**AGENDA FOR REGULAR MEETING  
VILLAGE OF TINLEY PARK  
PLAN COMMISSION  
March 5, 2015 – 7:30 P.M.  
Council Chambers  
Village Hall - 16250 South Oak Park Avenue**

**MAHER FUNERAL HOME (JOHN MAHER, PETITIONER) – 17101 71<sup>st</sup> AVENUE – SPECIAL USE PERMIT FOR AN ACCESSORY APARTMENT, FRONT YARD SETBACK VARIATION, AND SITE PLAN APPROVAL FOR A FUNERAL HOME (Commissioners McLeod and Ficaro)**

# PLAN COMMISSION

Site Plan, Special Use, and Variation Approval

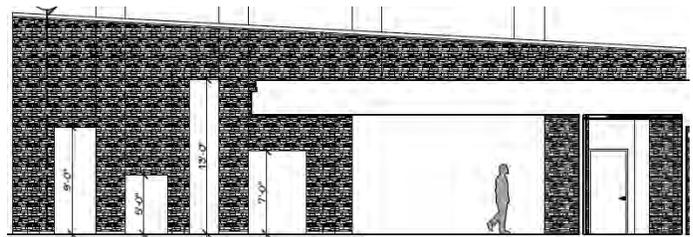
The Plan Commission has previously expressed concern regarding the use of Spandrel glass. Staff investigated alternate materials however the architect states that Spandrel glass is the best material choice and states that it is consistent with the appearance of the rest of the windows except for its opacity. The architect feels the use of Spandrel glass in this limited area “lends itself to the original building design by keeping the exterior simple and not introducing another element to conceal the interstitial space.”

Open Item #3: *The Commission may wish to discuss the use of Spandrel glass in the transom areas.*

**At the Assigned Commissioner Workshop, the Applicant agreed to use a gray color Spandrel glass instead of the black glass displayed at the 2/19/2015 Plan Commission meeting. The Applicant will bring a sample of the glass to the 3/5/2015 Public Hearing. Commissioner Ficaro felt this was a good choice and that it was a better match to the new windows.**

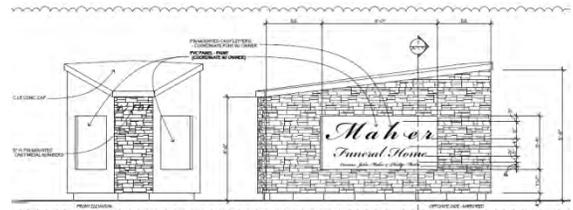
The architect has proposed all new mechanical systems and therefore the existing rooftop units will be replaced. The new units will be smaller in size (4'9") and will utilize the existing metal louvered screen. Staff has not been able to verify the height of the existing metal louvered screen

***Open Item #4:*** Staff has requested information on the height of the rooftop mechanical screen from the project architect. The goal is to ensure all rooftop mechanical units are properly screened.

**The Applicant has verified that the new HVAC units will be 4'9" in height and the existing metal louvered screen measures 5'2" in height. After some discussion at the Assigned Commissioner Workshop, attendees felt that the existing screen will provide the necessary screening for the rooftop units.**

**SHEET L-1**

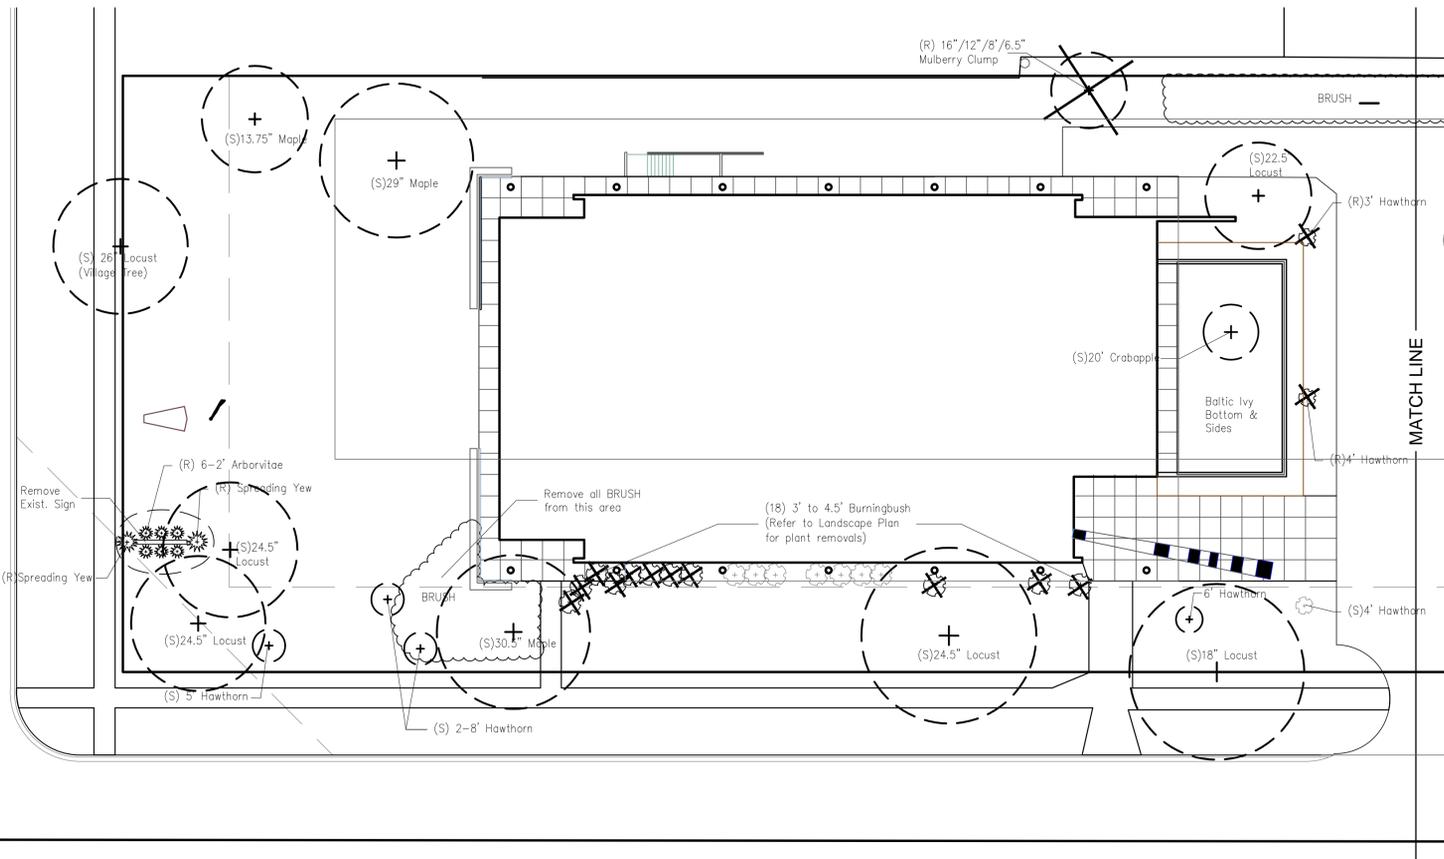
With regards to the landscape plan, MS. WALLRICH reported that Staff has requested additional plantings within the islands to prevent vehicles from trespassing across the islands. She added that additional landscape material has been

**Open Item #1:** Staff has recommended additional landscaping within the islands in the hope of preventing vehicles from trespassing across the islands. The most recent landscape plan provides for six (6), 24" Gro-low Sumac. Sumac is a very hardy shrub, however staff is recommending adding 5-6 larger, hardy evergreens shrubs that are greater in height (3-4'), such as Inkberry (*Ilex glabra*) or a variety of Juniper,

#	Open Items	Resolutions
1	Parking lot landscape islands are undersized and may be trespassed by vehicles	Additional landscape material has been proposed for the landscape islands; additional plant material has been provided on the 171 <sup>st</sup> Street frontage as part of the relocation of street trees and shade trees. Landscape Architect has recommended approval of the Landscape Plan as revised per plans dated 2/24/2015.
2	Outdoor lighting impact on neighborhood	Parking lot lighting will be turned off when funeral services are not scheduled; during funeral services lights will be turned off by 11:00 P.M., condition of Special Use.
3	Use of Spandrel glass	A gray Spandrel glass will be used in the transom areas.
4	Adequate screening of rooftop HVAC	Existing metal louver screens will screen new HVAC units.
5	Text on ground mounted sign is prohibited	Funeral Director’s name will be removed from sign.

**PROPOSED FINAL PUD PLAT**

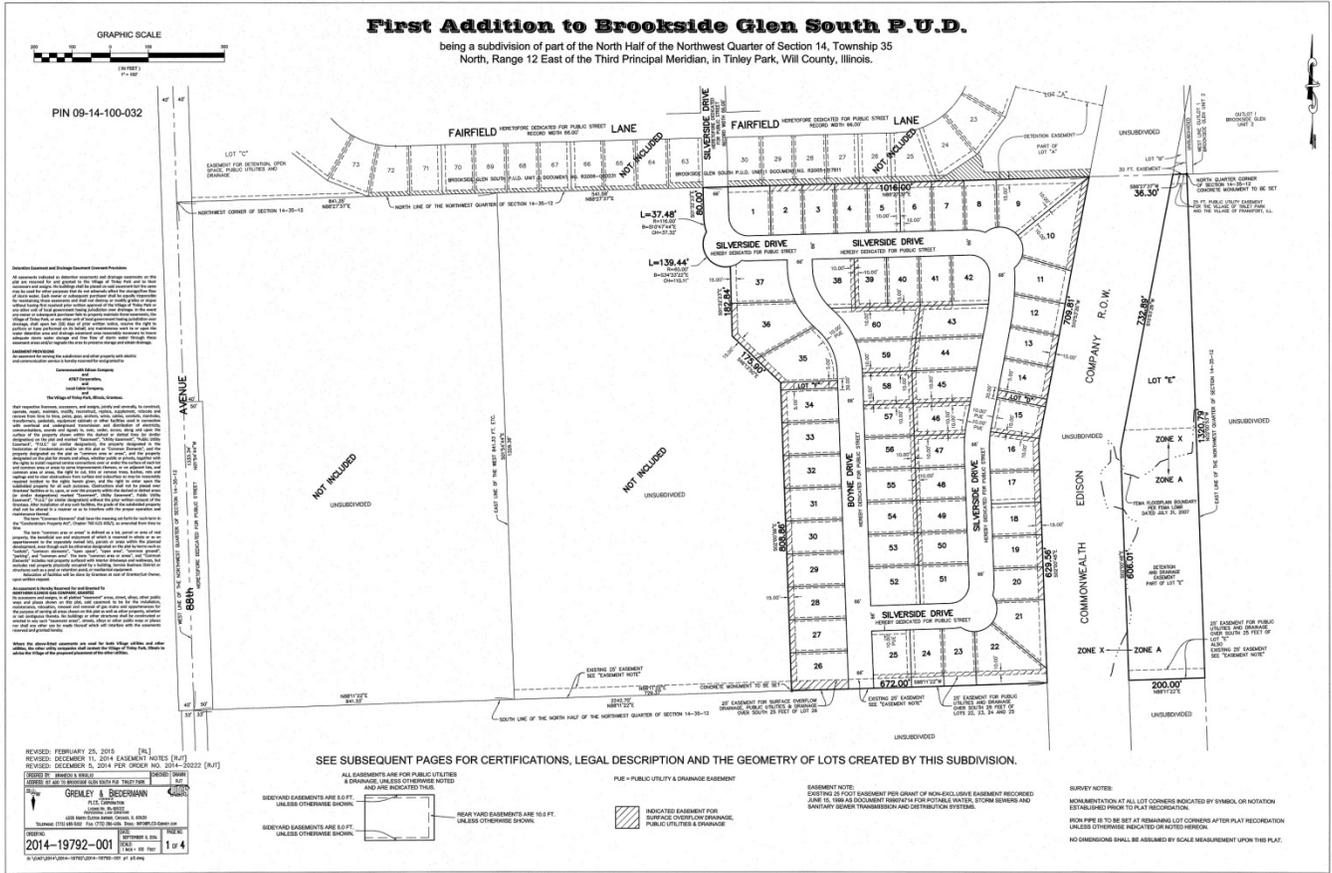
**Staff Commentary from 2015:** We would ask the petitioner to respond at our meeting whether or not connections across the ComEd ROW will be allowed and if any plans have been made to connect to the existing pathway system in Brookside Glen through the ComEd ROW. Also: When will the pathway connections be made?

- a. **Road Naming Conventions** – The establishment of a “circle” type of subdivision creates addressing challenges for the developer. After as many as three different road name plans, the Village Planning Department recommends that Silverside Drive travel south from the Brookside Glen subdivision to the north and turn due east, follow south, and turn back west. A second street will be named “Boyne Drive” and that street will be a north/south street on the west side of the subdivision. The addresses along Silverside Drive will continually number as if they are a north/south street so that 911 dispatch and emergency personnel can easily find the houses.

- b. **Village of Frankfort Public Utility Easement** – The Village of Frankfort has requested a 50’ public utility easement that benefits their Village and its expanding water and wastewater systems. The petitioner and Frankfort have agreed to a 25’ easement. The applicant has agreed to provide the easements and the Village of Tinley Park does not object to these easements being granted.

As discussed, this revised Plat now shows the street names as agreed upon. SilverSide Drive is shown to continue from the existing subdivision to the north and continue as the northern-most roadway and eastern-most roadway. Boyne Drive is now shown as the street name for the western-most roadway.

Sheet 2 of the Plat now shows the Easement Provisions for the Village of Frankfort. We have modified the Village of Frankfort's Standard Easement language that Mr. Brown sent to you. We believe this language better adapts to the easement being located within the Village of Tinley Park and also being granted to both the Village of Tinley Park and Village of Frankfort. We have, via a copy of this letter, sent an electronic file of this revised plat to Mr. Brown.
